Agenda Item: 7.10

Source: Fujitsu

Title: Proposal for Cell / URA Update procedure

Document for Decision

Figure 3) URA update procedure.

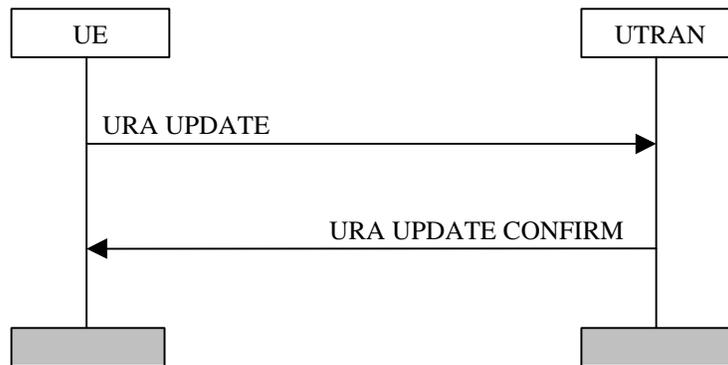
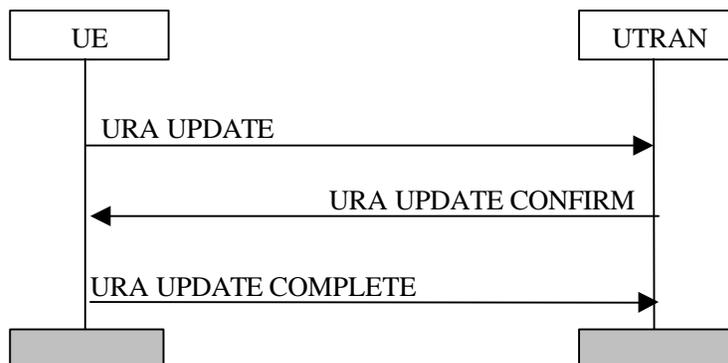
To summarise, it is possible that implicit RLC establishment procedure is desirable for Cell / URA update procedure. Therefore Cell / URA update procedures need an explicit Cell / URA UPDATE COMPLETE message on layer 3. ANNEX 2 is the proposed description in S2.31.

The UE establishes a radio link to a cell in the new URA. After that the UE sends a URA UPDATE message to the UTRAN. Upon reception of the message the UTRAN registers the change of URA, and sends a URA UPDATE CONFIRM message to the UE. The URA UPDATE CONFIRM message may include a new RNTI. When UE gets the new RNTI, UE sends the URA UPDATE COMPLETE message to UTRAN.

Credit for acknowledged transfer mode should be on URA UPDATE message and URA UPDATE CONFIRM message.
